## STAFF REPORT

<b>SUBJECT:</b>	PRS 21-0060	<b>PLANNING AREA:</b>	East Rural
<b>REQUEST:</b>	Minor Modification to an Approved PD	<b>SECTOR</b>	Central
<b>APPLICANT:</b>	Willaford Groves LLC		
<b>Existing Zoning:</b> PD 17-1005		<b>Comp Plan Category:</b> RES-1 & RES-6

**PRS 21-0060**

Figure 1: Existing Site Plan

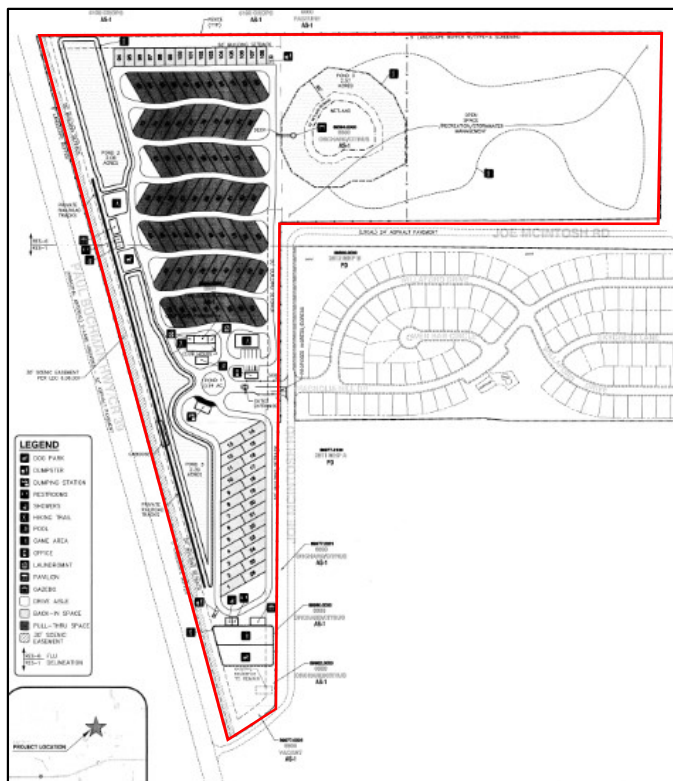
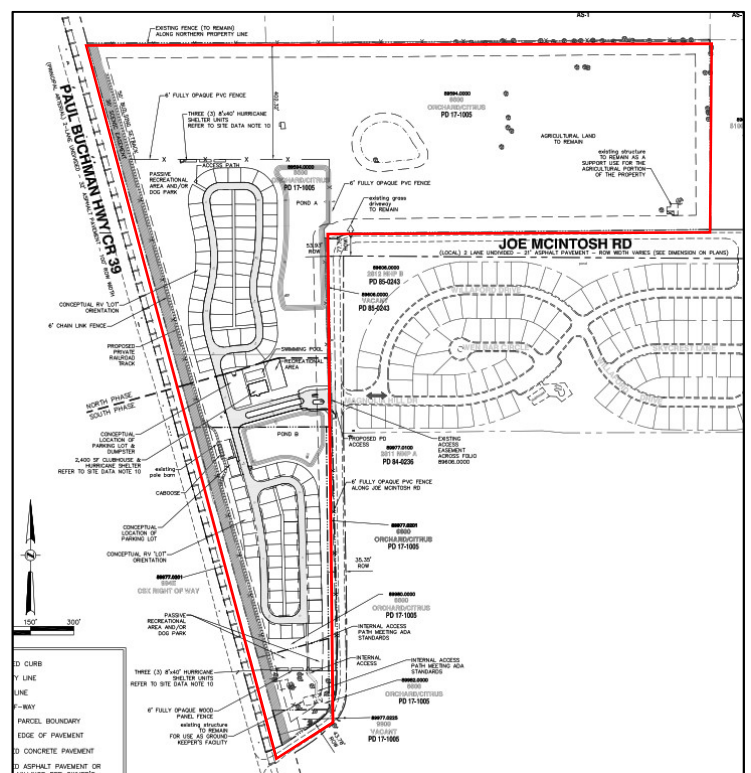
1. **A redesign of the RV park.** The currently approved site plan locates the 108 space RV park (with pull-thru and back in spaces) from the northern perimeter southward along the entire western portion of the site (see Figure 1). All stormwater ponds were located along the western area of the site. The eastern portion of the site is depicted as open space/recreation/stormwater management uses. Interim agricultural uses until the site develops is permitted. The proposed plan places all RV spaces away from the northern perimeter, at an increased setback from 50 feet to approximately 400 feet. The internal roadway configuration changes from a loop road with east/west streets to two loop roads. Stormwater ponds will now be located within or to the east of the RV park area. The central park area will contain a swimming pool, recreation area, and clubhouse/shelter building. An on-site "caboose" track and dog park areas continue to be provided where generally depicted on the existing site plan. The southernmost area of the PD is proposed to be used for a groundskeeper facility (not a residence). Required screening of the RV park area will continue to be provided.

1. The site plan submitted for certification is to identify the north and northeast area as “open space/recreation/stormwater management” as currently approved and not proposed for modification under this application.

FENCE

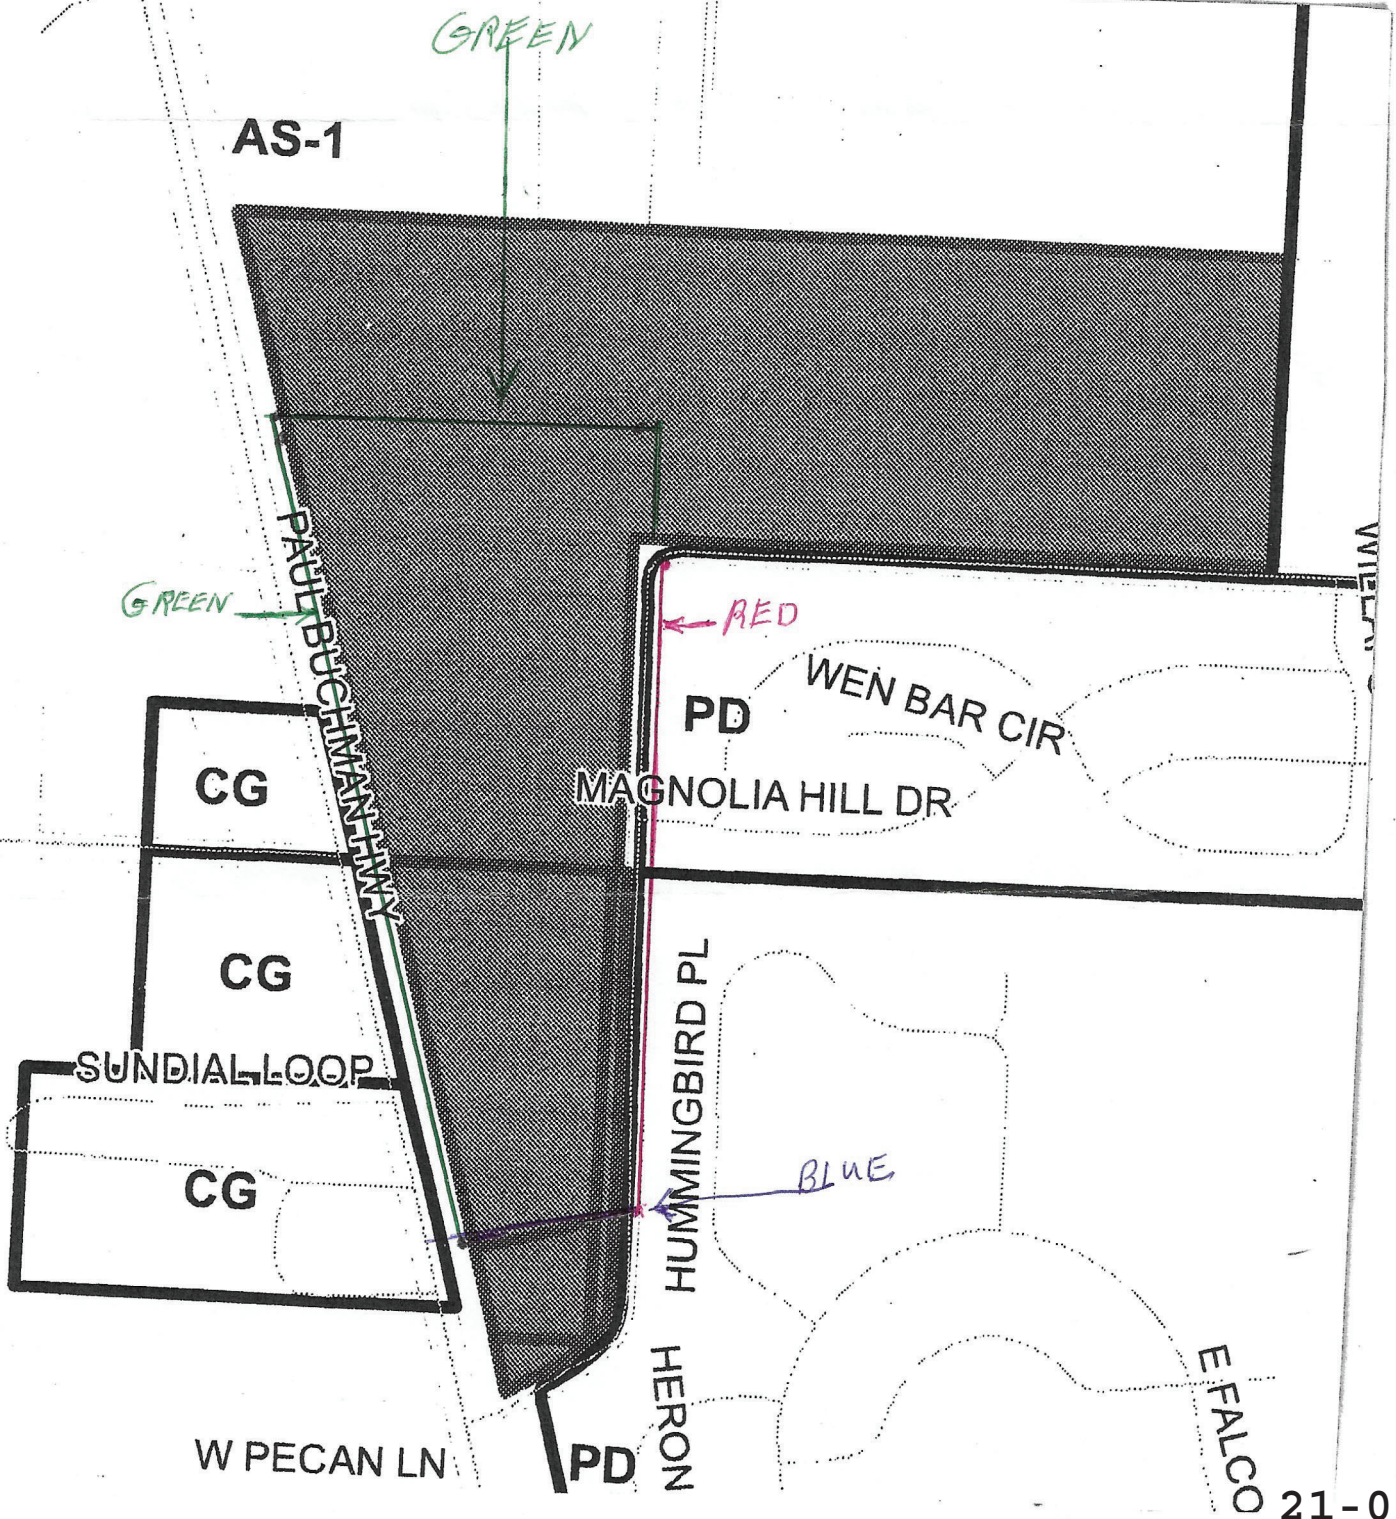
*Specific Variation Requested to Section 6.06.06 screening/fencing requirement for 6' opaque fence along property line separating s.f. from RV Park. Buffer Matrix Section 6.06.06 Standards. The proposed plan reflects a proposed 6' chain link fence along the north RV Park boundary vs actual property line offering greater buffer and separation.*

*The proposed use of this parcel has been amended from initial PD rezoning to only a portion of the original 48 acre parent tract to only a 108 unit portion on the western frontage of Paul Buchman Highway. This redesign, as proposed by this Minor Modification, reflects only two small phases north and south and lessens out the northern and eastern portions previously zoned PD. This new design offers a more efficient and creative 'cluster' design that essentially creates to pods and curvilinear loop roadway reducing unnecessary impervious surface and more efficiently utilizing land area. This redesign now places the closest development area to be in excess of 450' from the north property line where the applicant's own orange grove will serve as a buffer with scattered citrus grove trees existing. Further, the redesign only reflects 5 RV lots on the northern portion with no perimeter roadway being external with a pond and passive recreation area occupying the remainder of this site. The applicant seeks a 6' high chain link fence along the development pod north area while still maintaining Ag fencing and Ag uses/grove trees on the remainder property and along property boundary of northern parcel.*
